Third Addendum to the Los Angeles Memorial Coliseum Renovation Project EIR

Existing and Proposed Video Board Graphics

**Los Angeles Memorial Coliseum
Potential Impacts of Approved vs. Modified
Project on Character-Defining Features
Review of Additional Modifications
Third Addendum, November 23, 2016**

PROPOSED SCOREBOARD

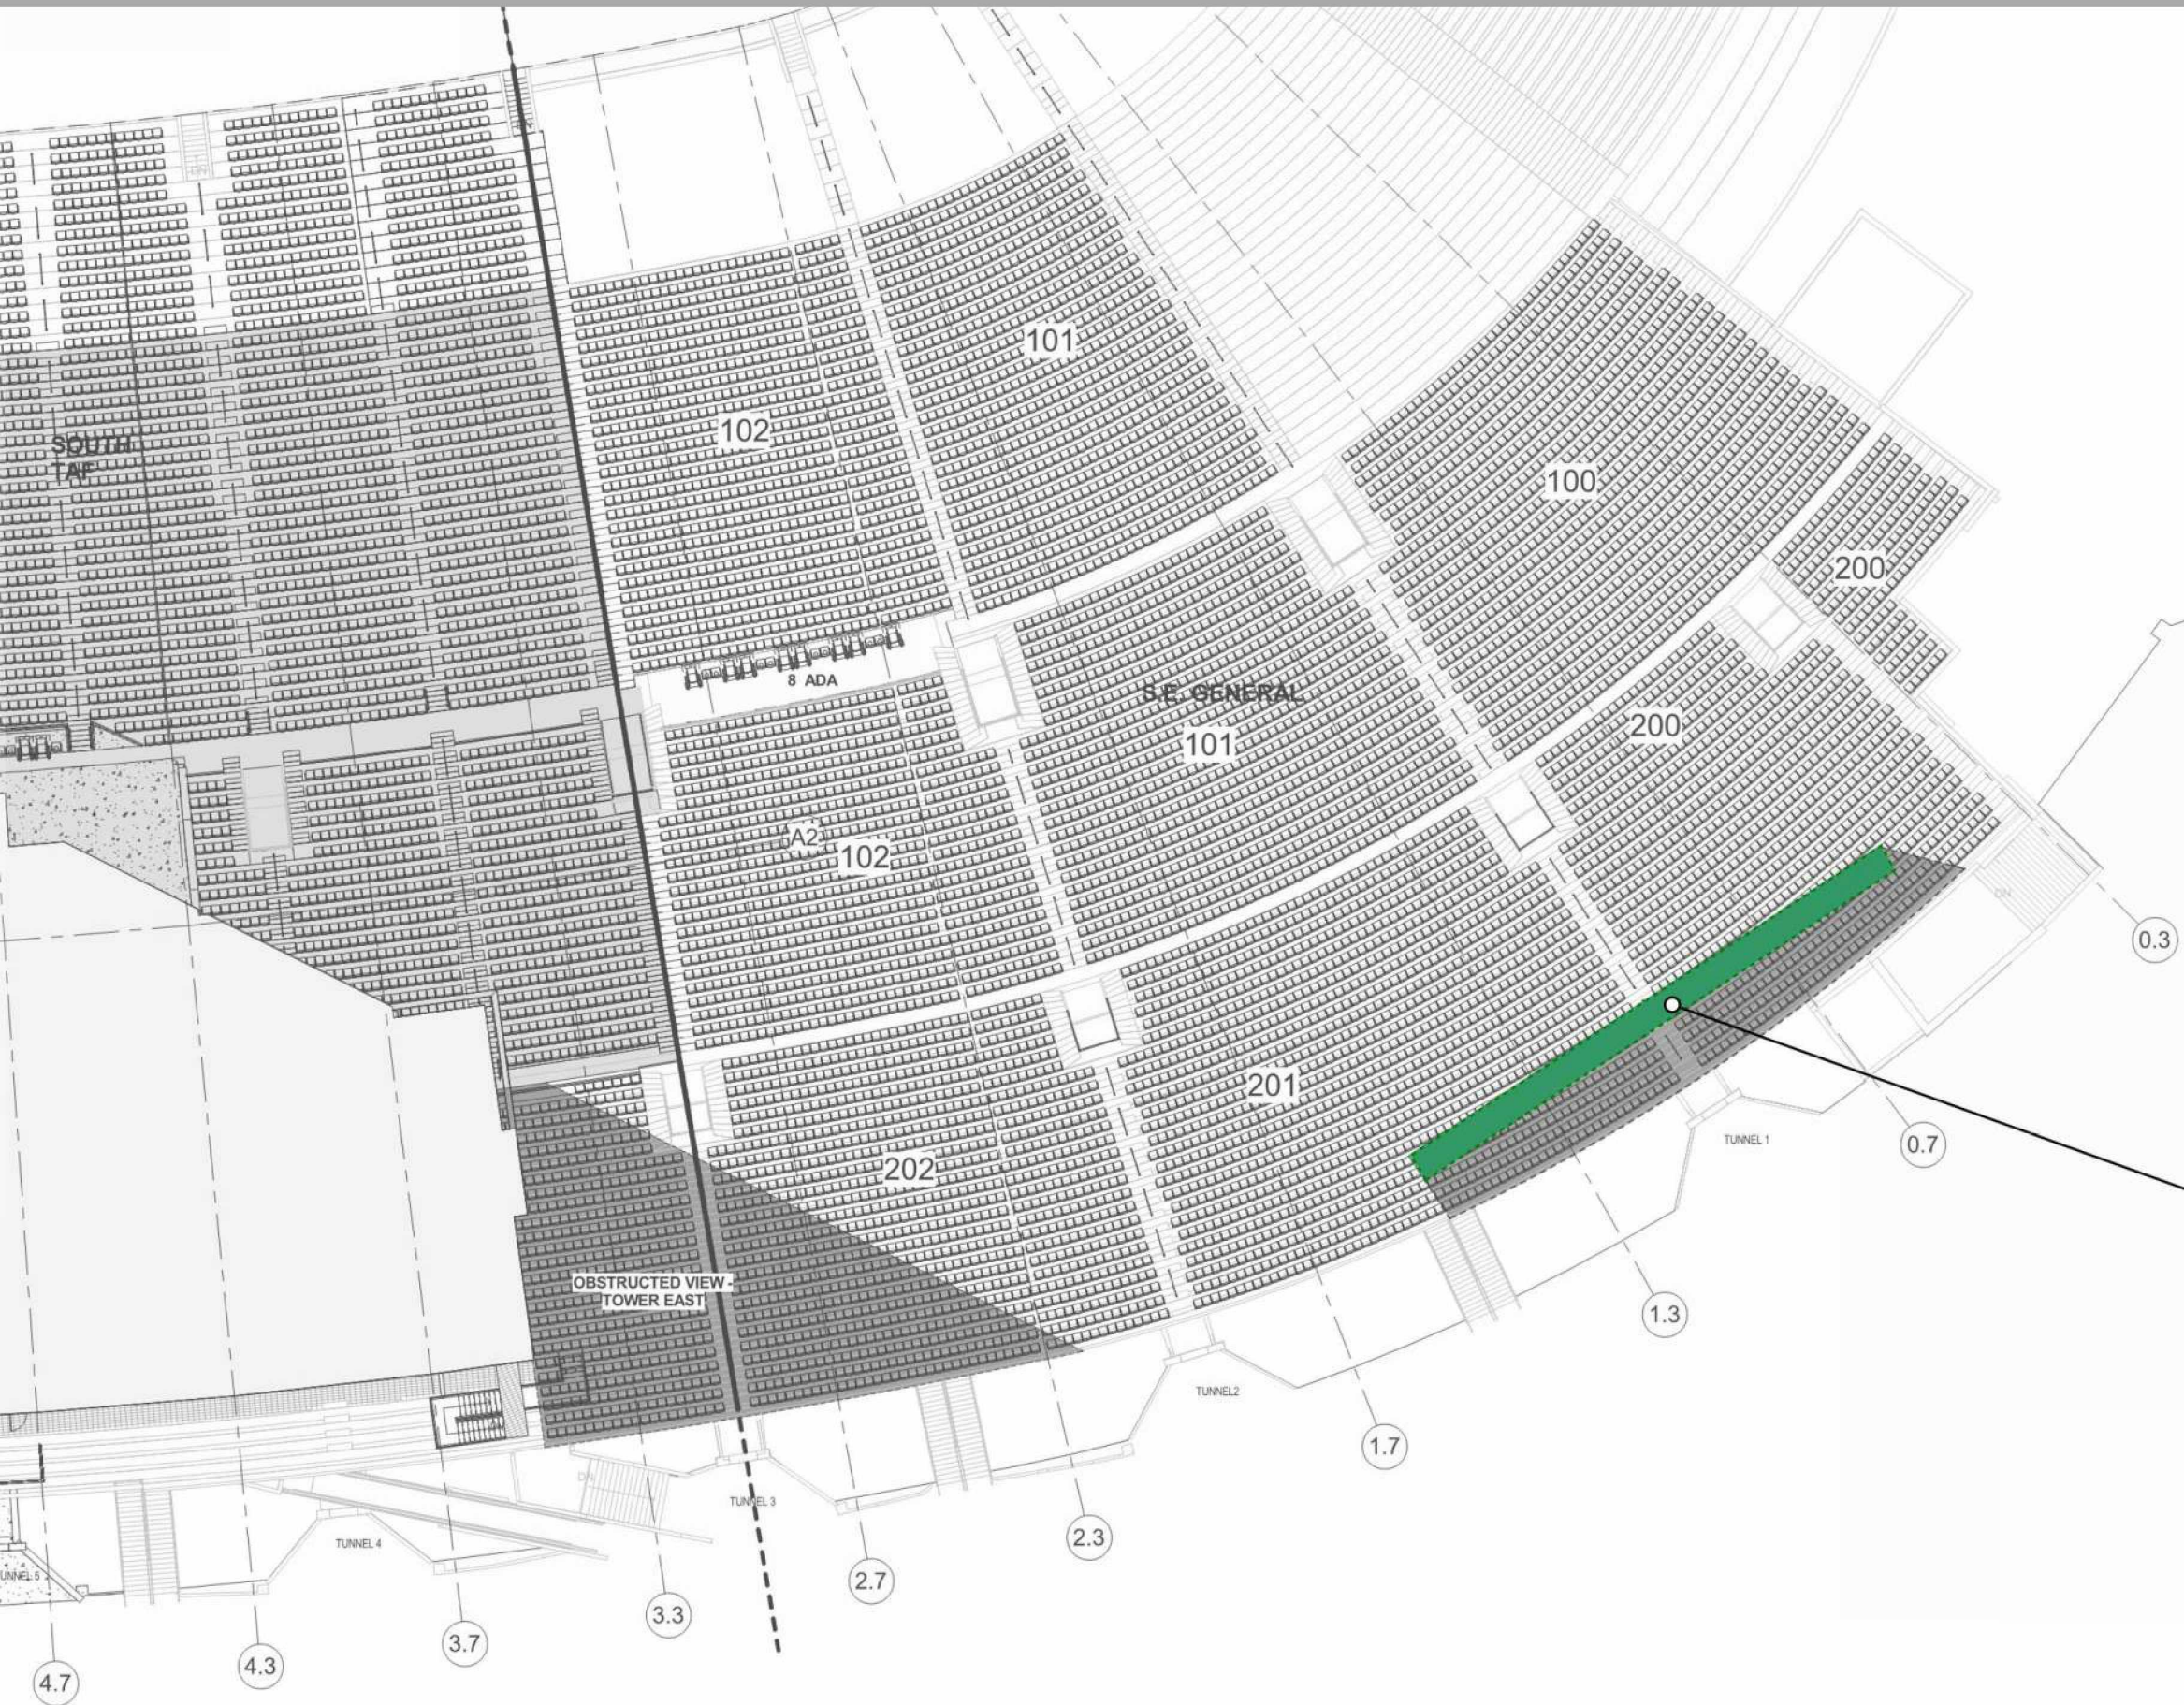
EXISTING SCOREBOARDS TO BE REMOVED

This option is mirrored in the NE corner of the Coliseum as well.

SCOREBOARD
Supported by existing bowl columns along grid E.

SECTION OF PROPOSED SCOREBOARD

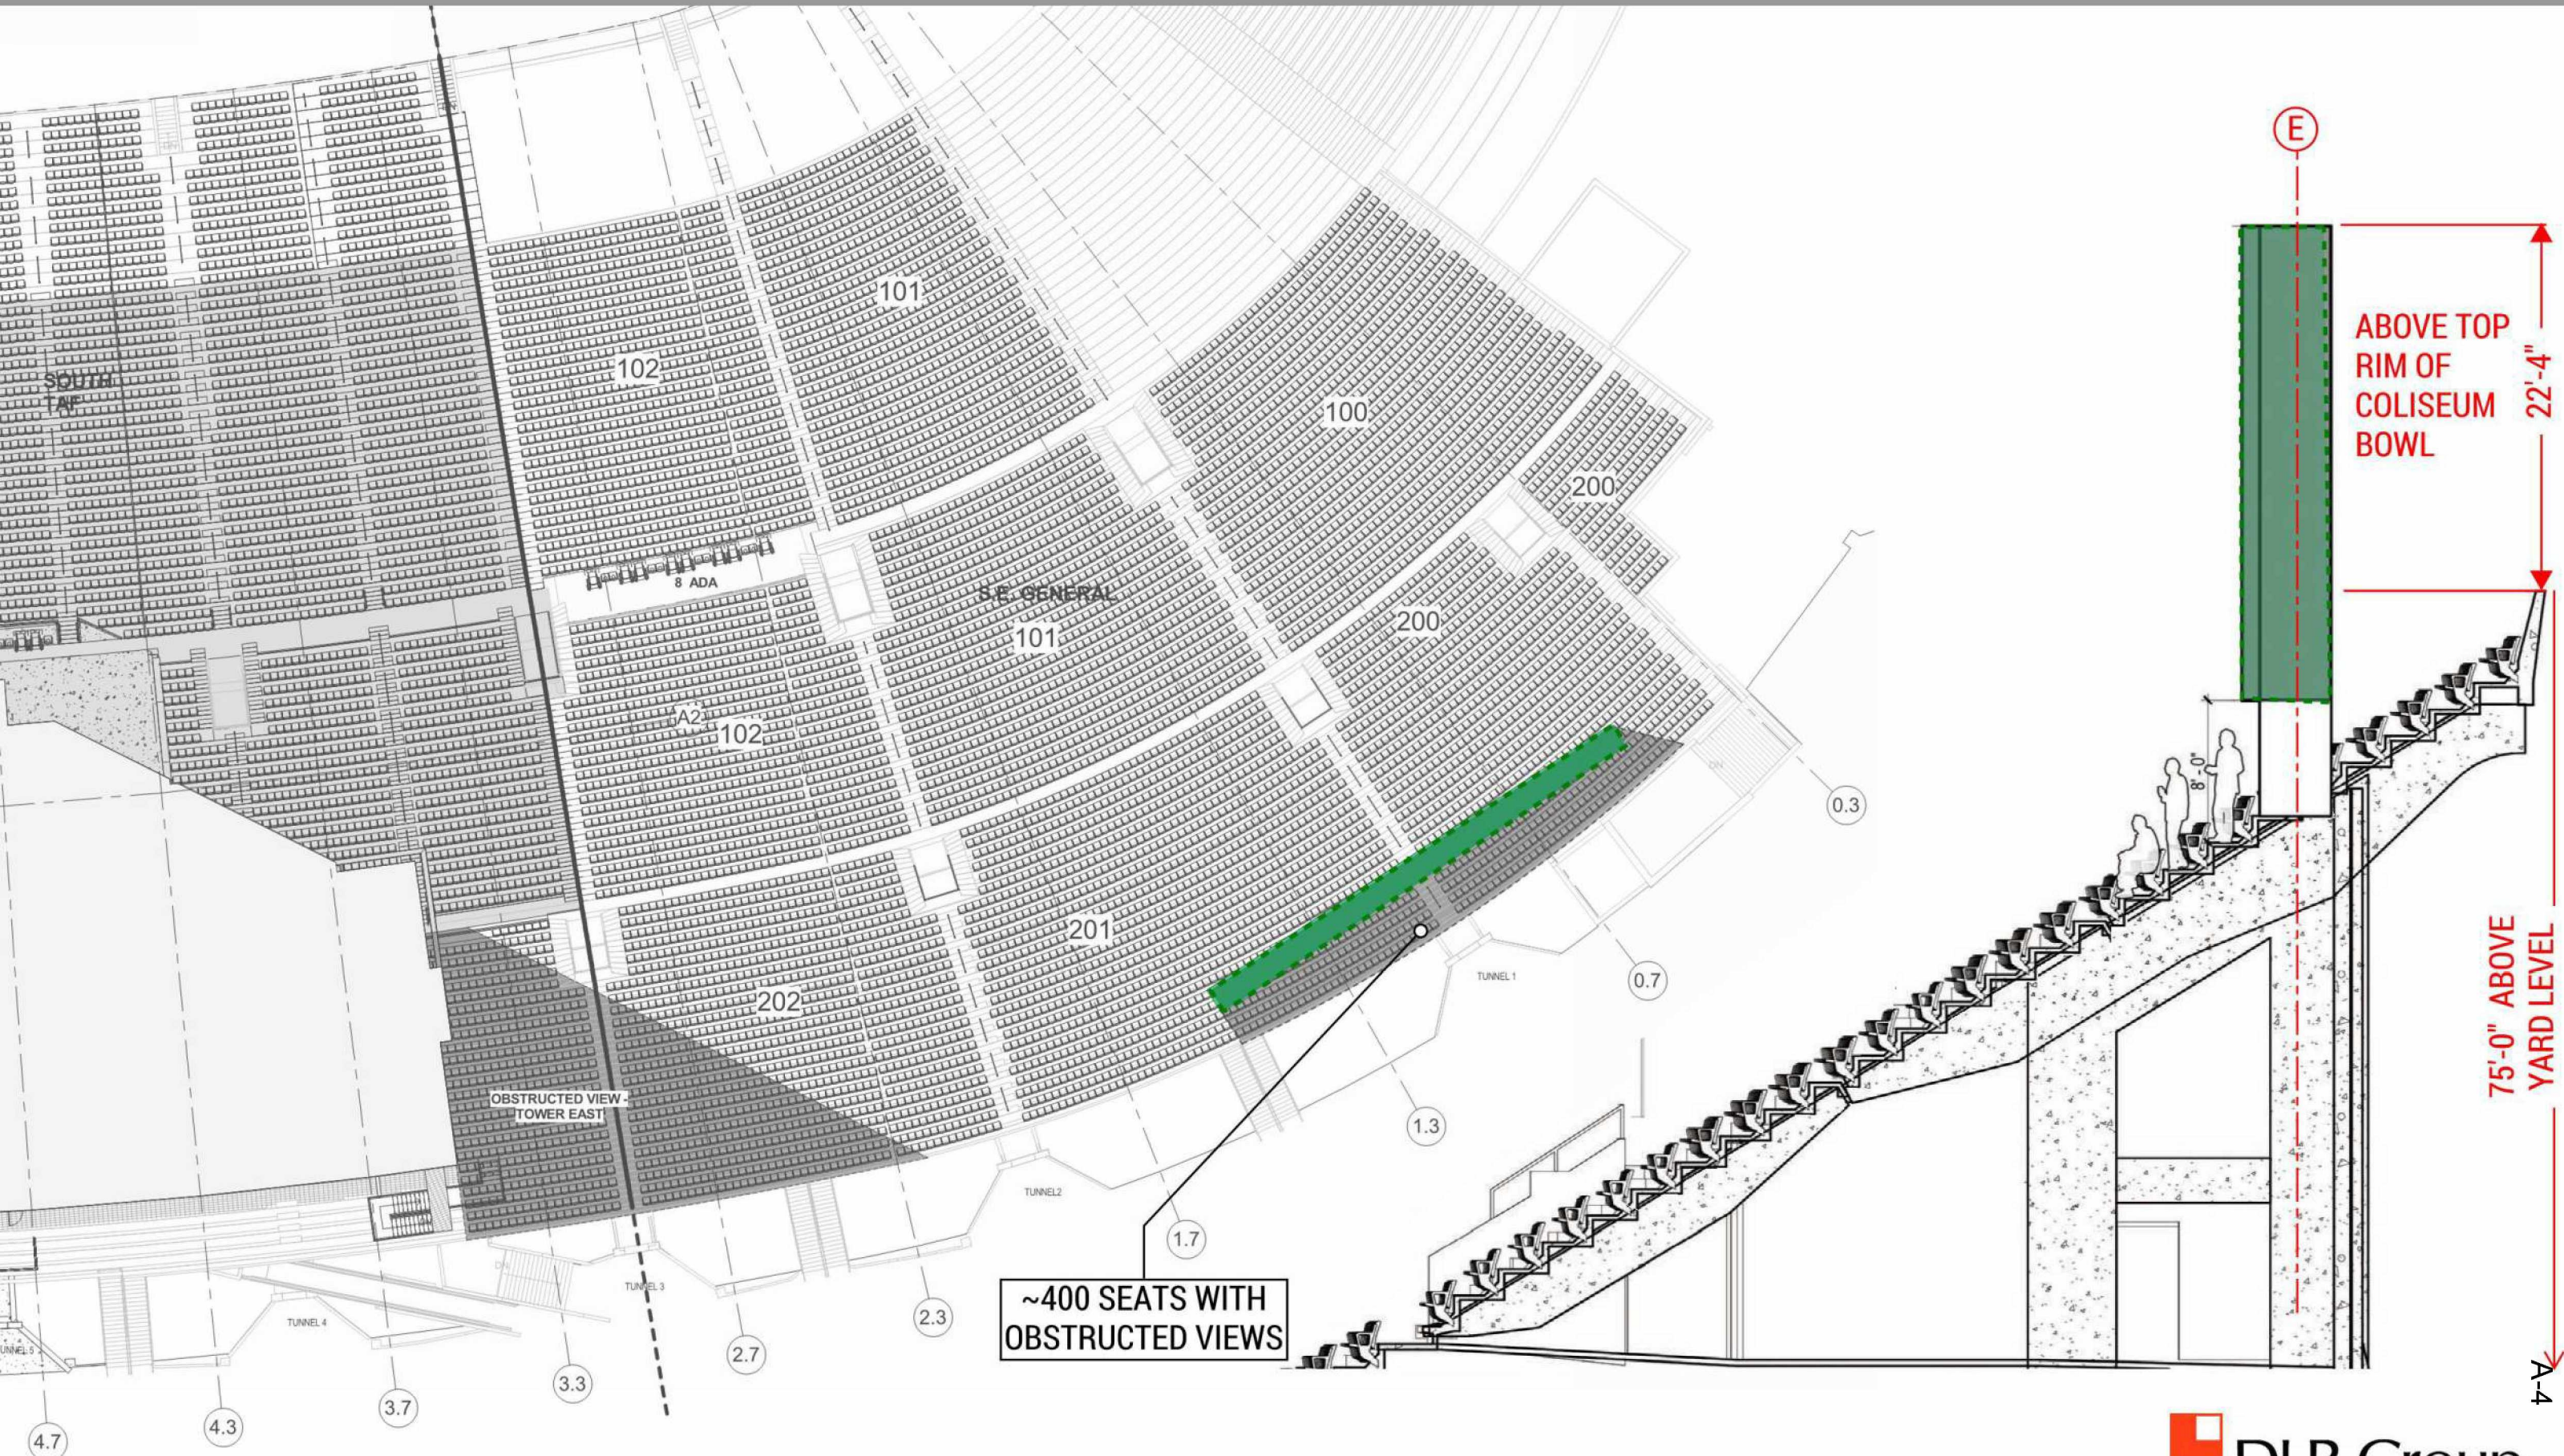
Support columns rest on existing bowl columns along grid E.

VIEWING ANGLES WITH PROPOSED SCOREBOARD

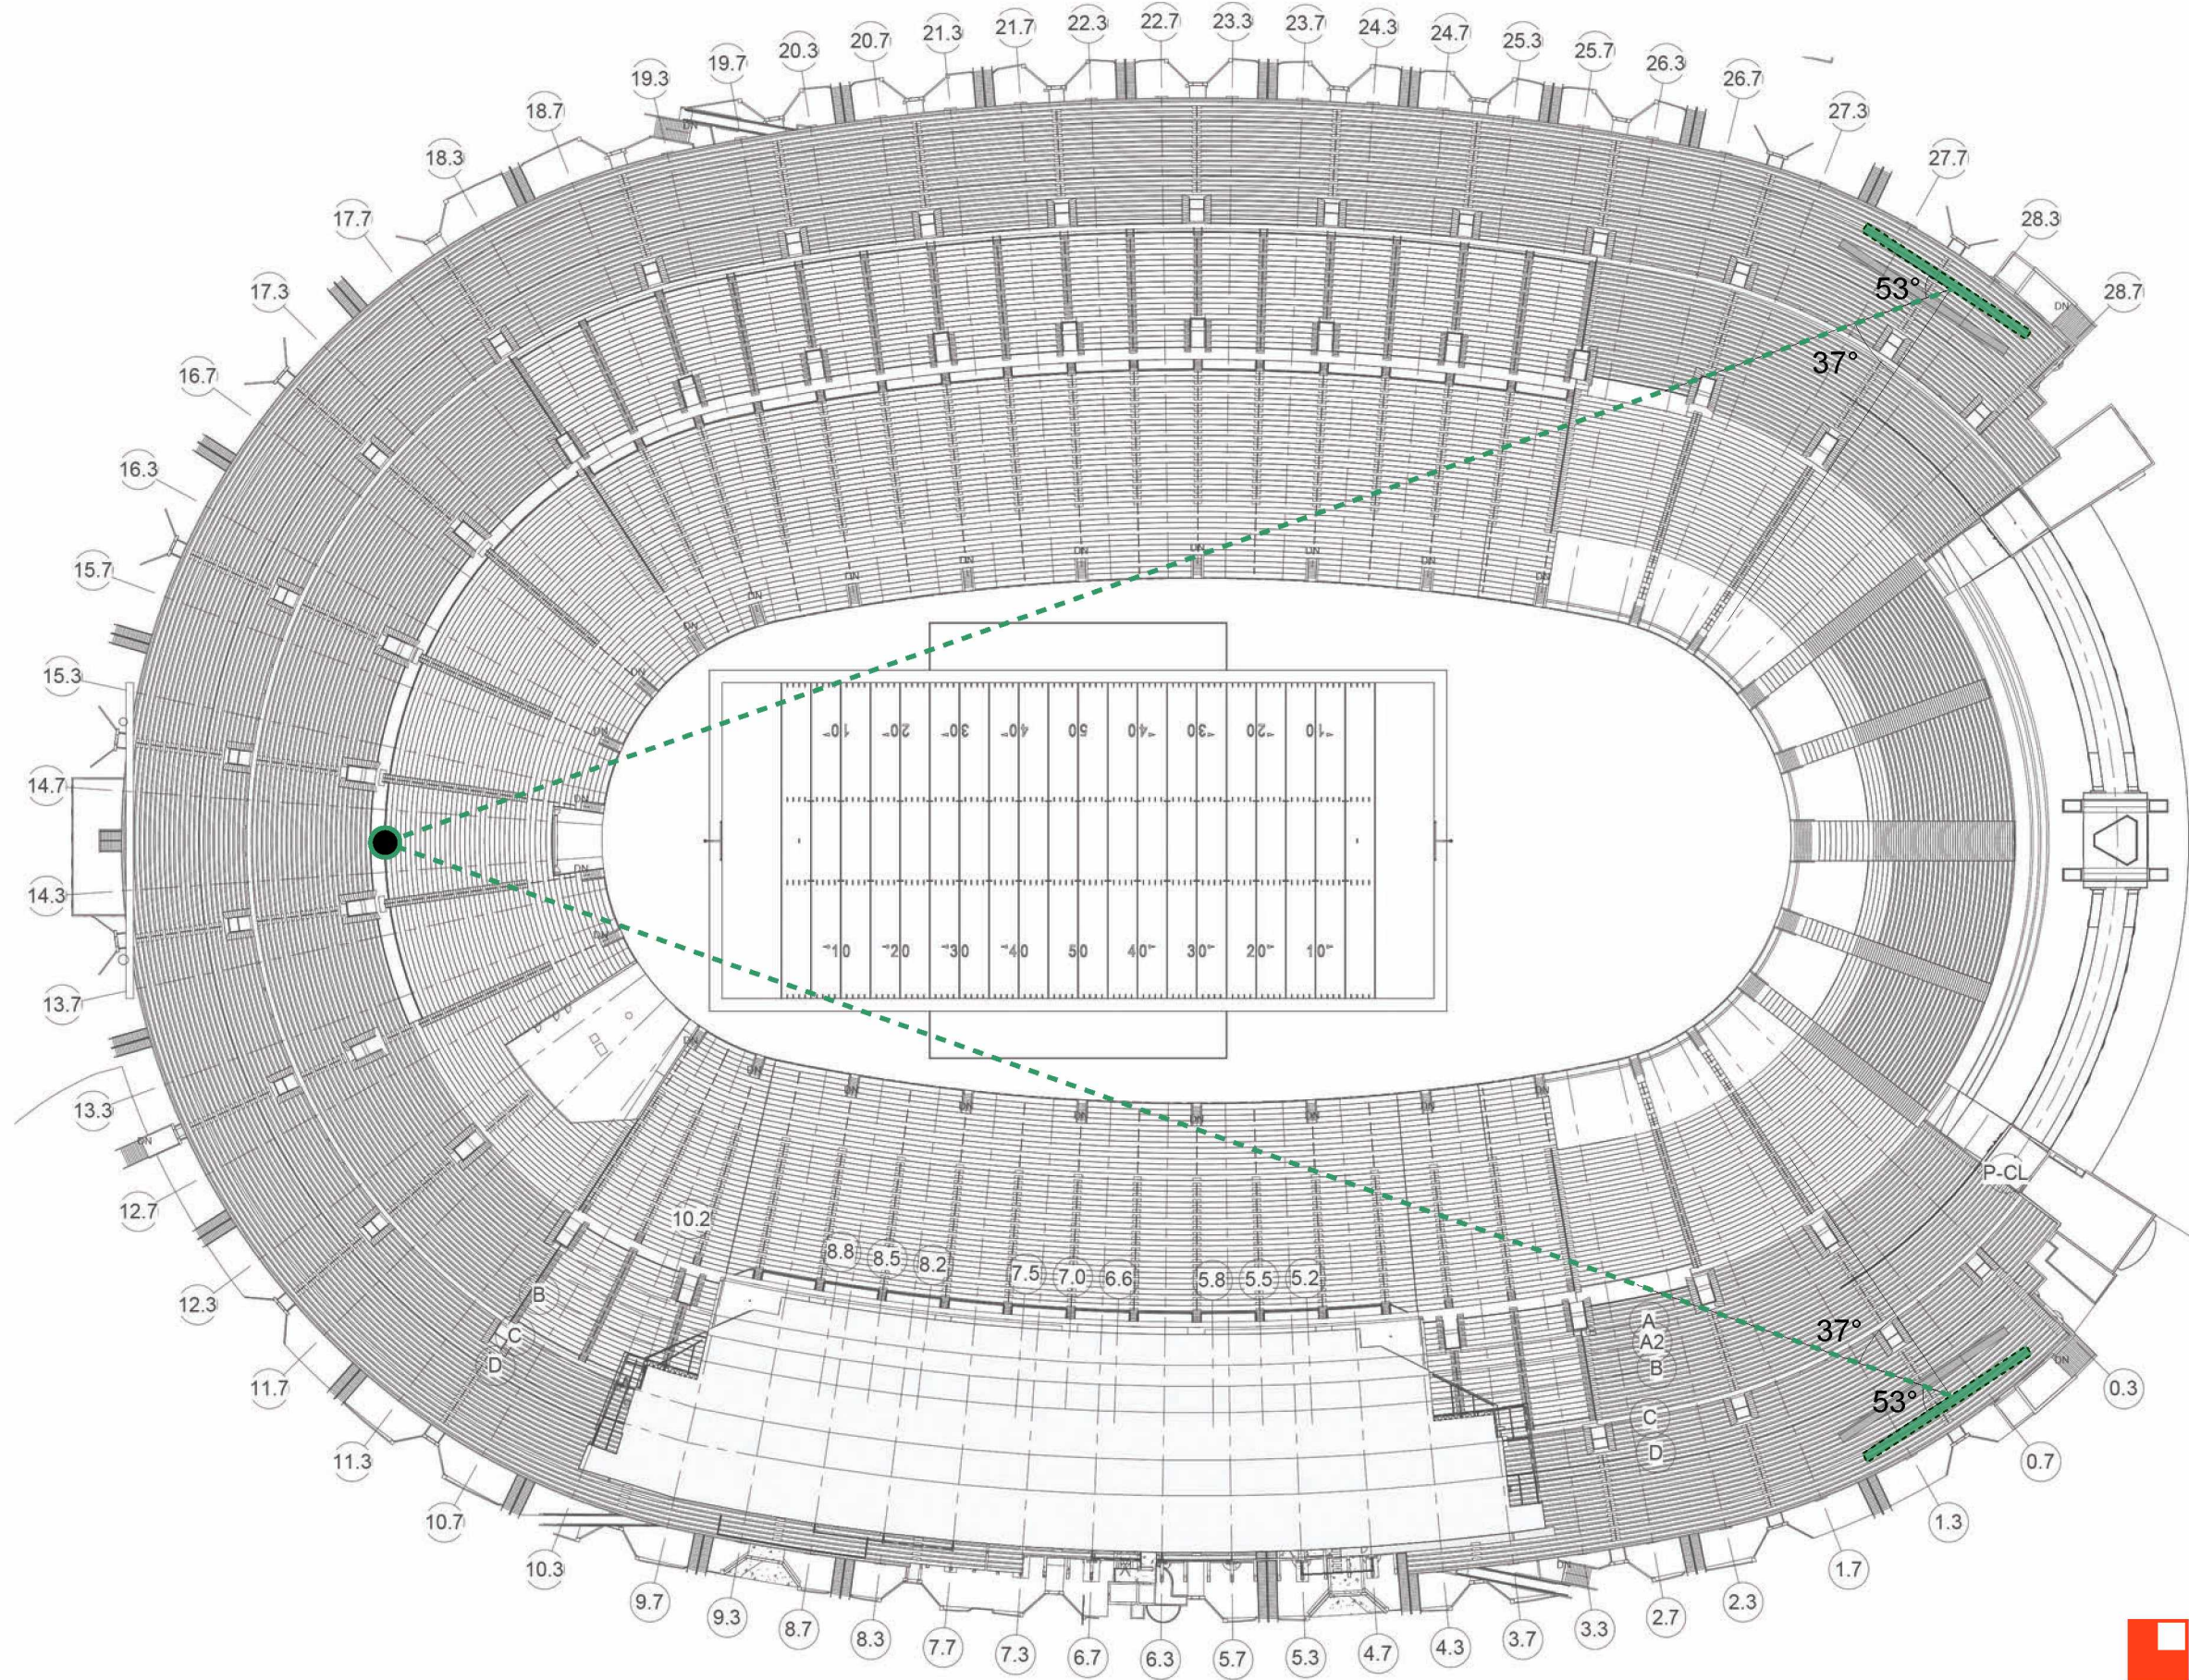
Viewing angle is within recommended criteria.
